**SERVICE BULLETIN**

N° 139-656

ATA 21 - INSTALLATION OF ENVIRONMENTAL CONTROL SYSTEM (ECS) HIGH EFFICIENCY PARTICULATE AIR (HEPA) FILTER

AW139 helicopter S/N 31762.

Figure 1

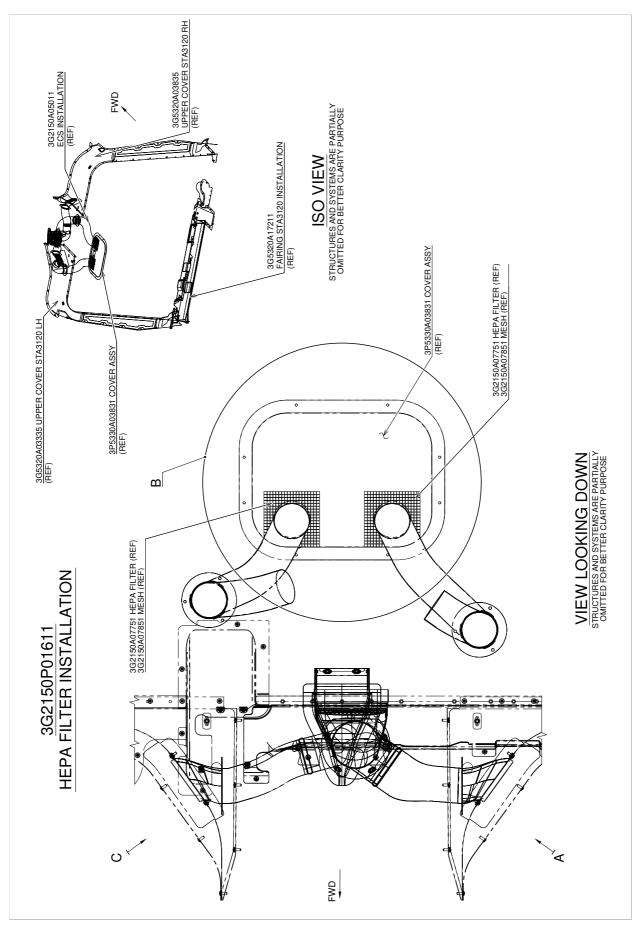
- 6.1 With reference to Figure 1, remove the cover assy P/N 3P5330A03831.
  - 6.2 With reference to Figure 3, temporary locate n°2 HEPA filters P/N 3G2150A07751 on the cover P/N 3P5330A03831.

- 6.5 With reference to Figure 1, re-install the cover assy P/N 3P5330A03831 by means of previously removed fixing hardware.
- 6.6 With reference to Figure 2 and Figure 5 section E-E, install HEPA filter P/N 3G2150A08151 and mesh P/N 3G2150A08351 by means of 3M scotch tape n°363 (C260) as required, on the internal side of the composite cover HEPA filter assy LH P/N 3G2150A07931.
- 6.7 With reference to Figure 4, install HEPA filter P/N 3G2150A08151 and mesh P/N 3G2150A08351 by means of 3M scotch tape n°363 (C260) as required, on the internal side of the composite cover HEPA filter assy RH P/N 3G2150A08031.

- 6.8 With reference to Figure 1 and Figure 5 Section F-F, remove upper cover STA3120 LH P/N 3G5320A03335 and upper cover STA3120 RH P/N 3G5320A03835 from the helicopter.

- 6.15 With reference to Figure 1 and Figure 5 Section F-F, re-install upper cover STA3120 LH P/N 3G5320A03335 and upper cover STA3120 RH P/N 3G5320A03835 on the helicopter by means of previously removed fixing hardware.

Figure 2

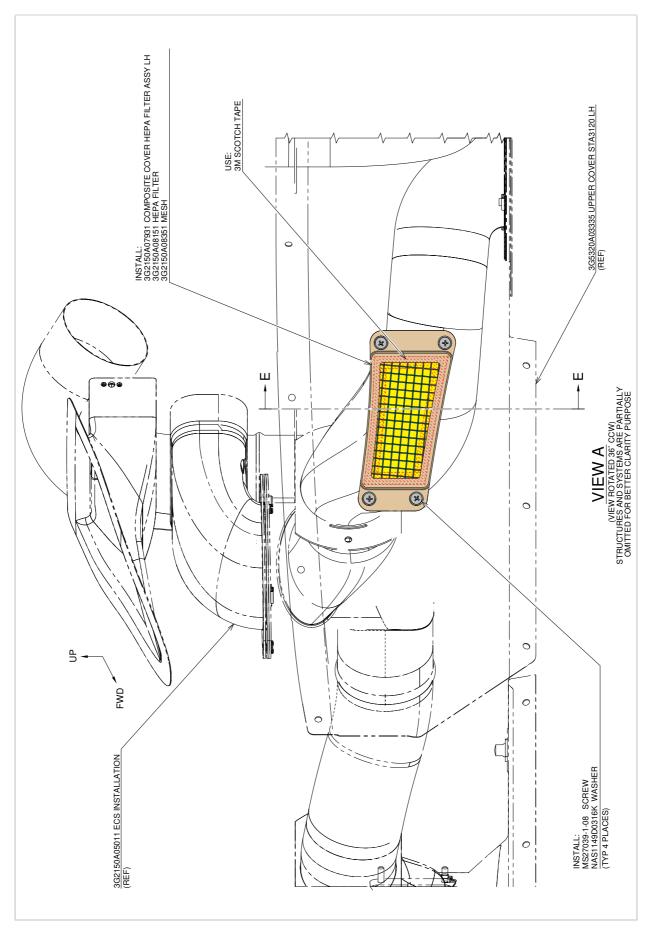
- 6.9 With reference to Figure 2 and Figure 5 Section F-F, temporarily locate composite cover HEPA filter assy LH P/N 3G2150A07931 on the upper cover STA3120 LH P/N 3G5320A03335 and countermark the positions of existing screw holes.

- 6.16 With reference to Figure 2 View A, if necessary remove existing cover from the upper cover STA3120 LH P/N 3G5320A03335 (or alternative P/N) and install composite cover HEPA filter assy LH P/N 3G2150A07931 by means of n°4 screws P/N MS27039-1-08 and n°4 washers P/N NAS1149D0316K.

Figure 3

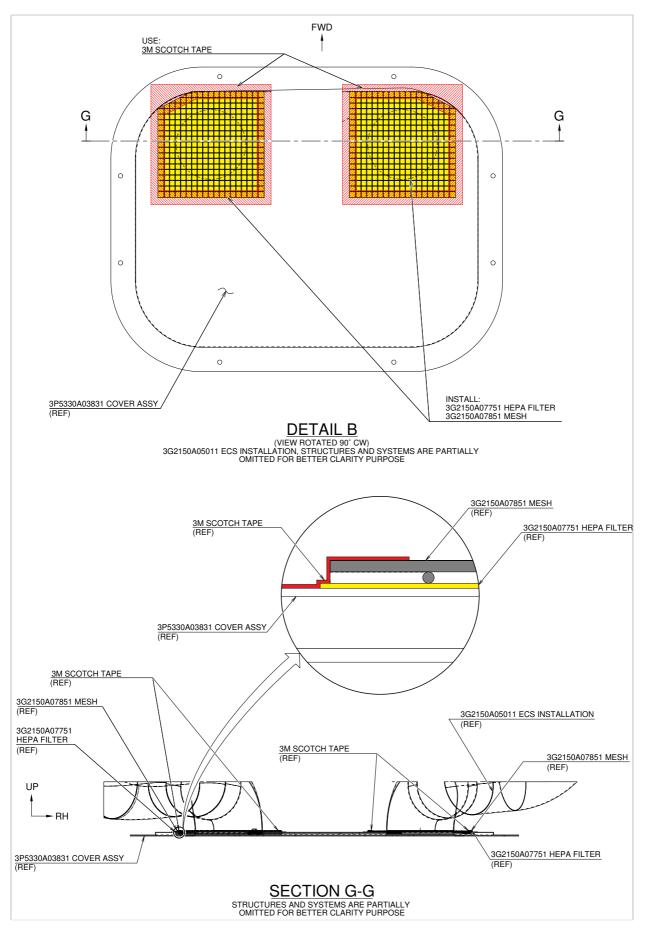
6.3 Using the cover P/N 3P5330A03831 as template countermark positions of the holes on the filtes P/N 3G2150A07751. Drill holes as required through the filters P/N 3G2150A07751.

6.4 With reference to Figure 3, install n°2 HEPA filters P/N 3G2150A07751 and n°2 meshes P/N 3G2150A07851 by means of 3M scotch tape n°363 (C260) as required, on the internal side of the cover assy P/N 3P5330A03831.

Figure 4

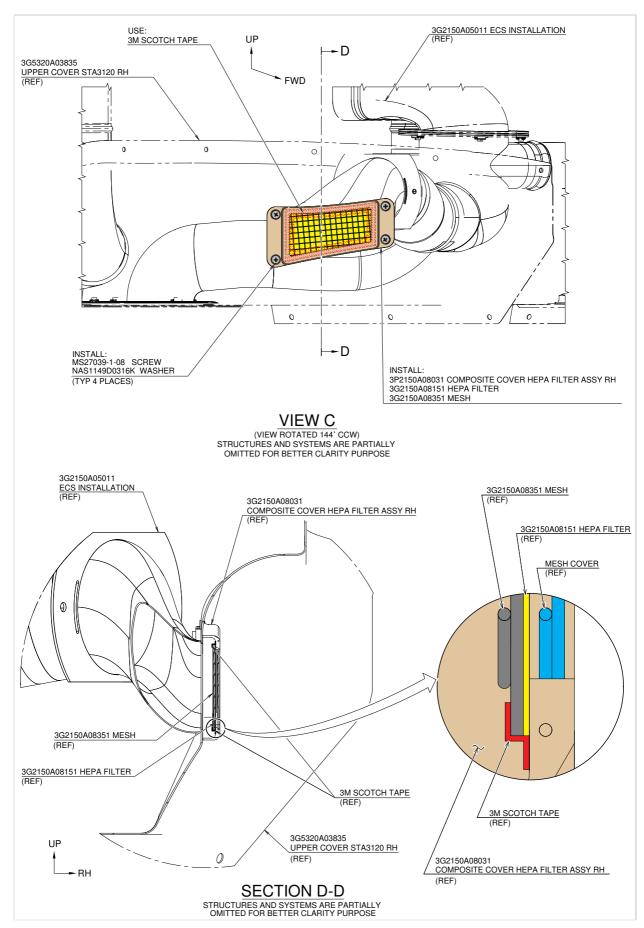
- 6.12 With reference to Figure 4 and Figure 5 Section F-F, temporarily locate composite cover HEPA filter assy RH P/N 3G2150A08031 on the upper cover STA3120 RH P/N 3G5320A03835 and countermark the positions of existing screw holes.

- 6.17 With reference to Figure 4 View C, if necessary remove existing cover from the upper cover STA3120 RH P/N 3G5320A03835 (or alternative P/N) and install composite cover HEPA filter assy RH P/N 3G2150A08031 by means of n°4 screws P/N MS27039-1-08 and n°4 washers P/N NAS1149D0316K.

Figure 5

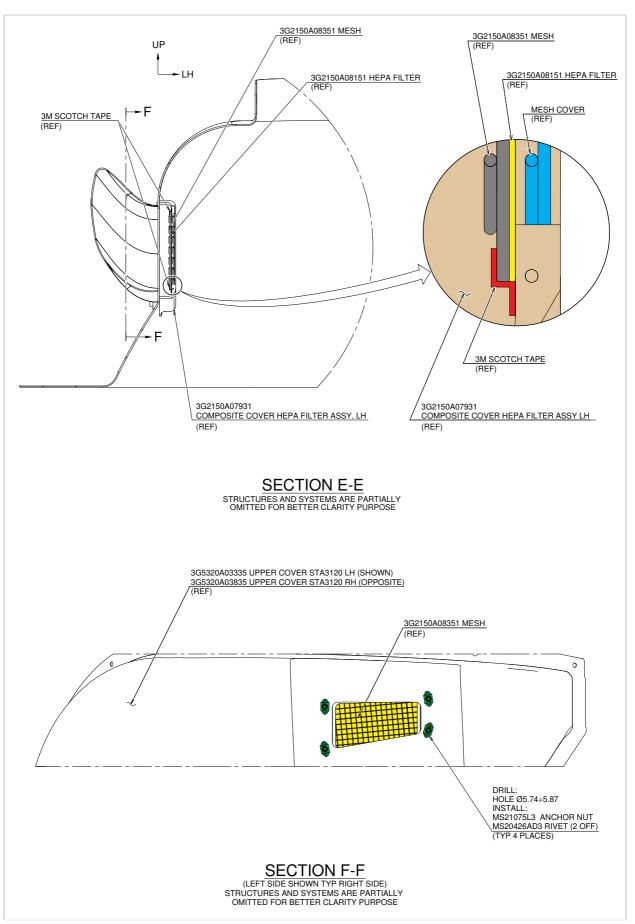
Perform following steps 6.8 thru 6.15 only if upper cover STA3120 LH P/N 3G5320A03335 (or alternative P/N) and upper cover STA3120 RH P/N 3G5320A03835 (or alternative P/N) are not equipped with anchor nuts (Ref. Figure 5 Section F-F). Otherwise skip to step 6.16.

- 6.10 With reference to Figure 5 Section F-F, drill n°4 holes Ø 5.74÷5.87 on the upper cover STA3120 LH in correspondence of previously marked positions.

- 6.11 With reference to Figure 5 Section F-F, install n°4 anchor nuts P/N MS21075L3 by means of n°8 rivets P/N MS20426AD3-4 on the upper cover STA3120 LH.

- 6.13 With reference to Figure 5 Section F-F, drill n°4 holes Ø 5.74÷5.87 on the upper cover STA3120 RH in correspondence of previously marked positions.

- 6.14 With reference to Figure 5 Section F-F, install n°4 anchor nuts P/N MS21075L3 by means of n°8 rivets P/N MS20426AD3-4 on the upper cover STA3120 RH.

Figure 6

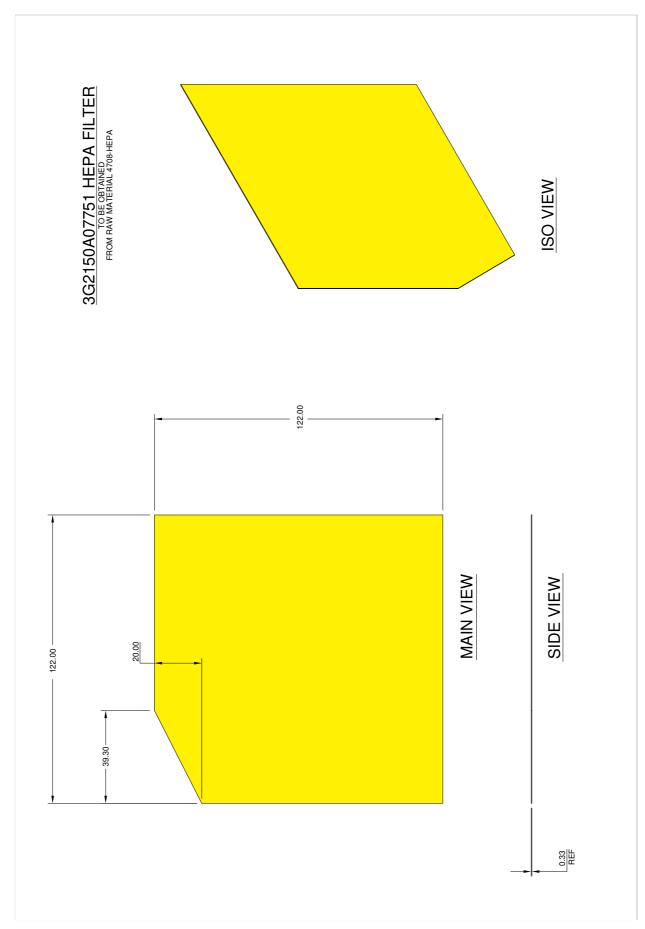
- 2. With reference to Figure 6, if necessary manufacture n°2 HEPA filters P/N 3G2150A07751 from the raw material P/N 4708-HEPA.
- 3. With reference to Figure 8, if necessary manufacture n°2 HEPA filters P/N 3G2150A08151 from the raw material P/N 4708-HEPA, use cover P/N 3G2150A07931 as template.

Figure 7

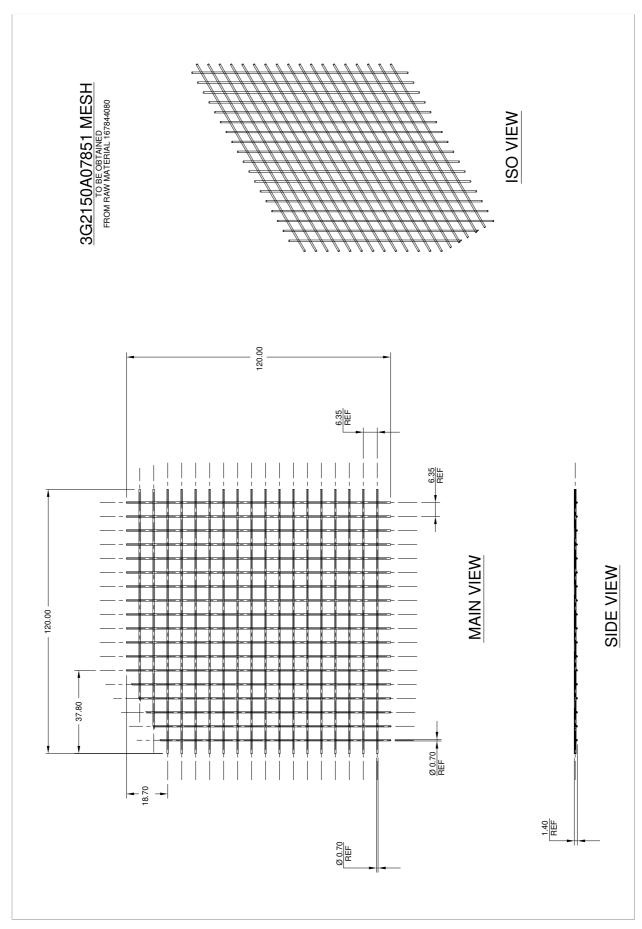
- 4. With reference to Figure 7, if necessary manufacture n°2 meshes P/N 3G2150A07851 from the raw material P/N 167844080.
- 5. With reference to Figure 9, if necessary manufacture n°2 meshes P/N 3G2150A08351 from the raw material P/N 167844080, use cover P/N 3G2150A07931 as template.
